April 24, 2019

HISD 2018 Bond Package 1  
West Central Elementary  
High School  
Hereford, Texas  
CHA# 1904

### **Addendum Three**

4 CANOPY EAVE  
 1" ■ 1'-0"

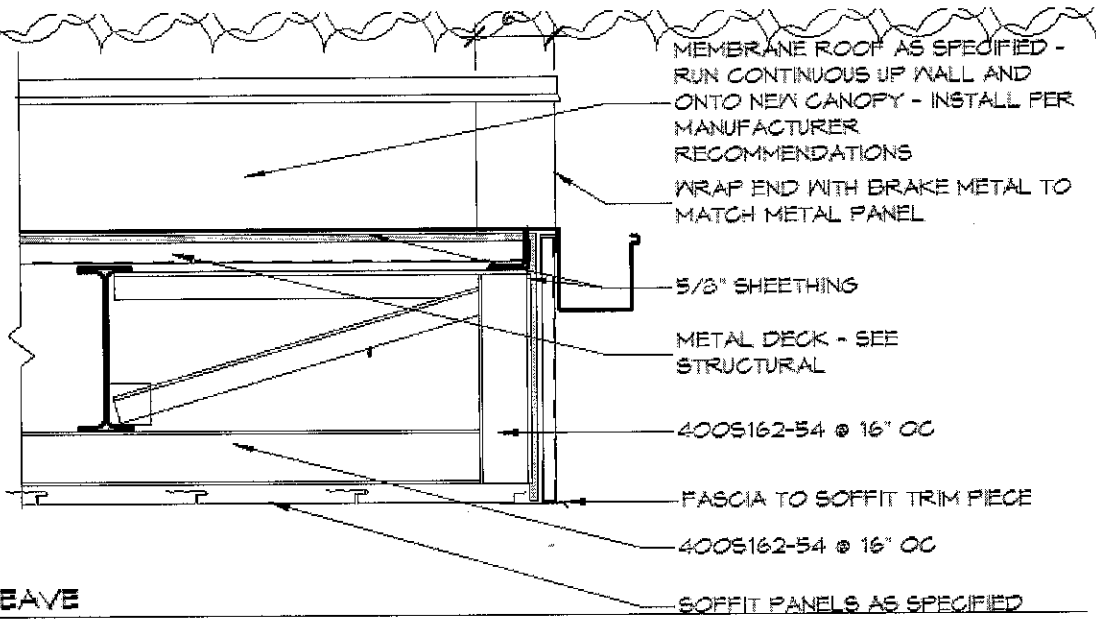
Attached: Revised Detail 4/A203W and 5/A203W

1. Portions of existing ceilings and flooring are to be removed and reinstalled to accommodate existing joist modifications required in addendum 1.
2. Typical all new parapet framing at West Central – 3 5/8” studs at 16” OC to be provided as infill between structural steel framing shown on structural detailing.
3. General clarification – all structural steel shown on the structural plans to be provided as detailed whether shown on architectural details or not. Structural plans to supersede architectural in terms of framing materials and configuration. Revised architectural details will be issued as needed
4. Replace detail 5/A103W with revised detail attached.
5. Replace detail 4/A103W with revised detail attached.
6. Masonry column wraps to extend to elevation 108'-10”.

3 5/8" METAL STUD INFILL BETWEEN STRUCTURAL SUPPORTS - SEE FRAMING DETAILS ON STRUCTURAL SHEETS
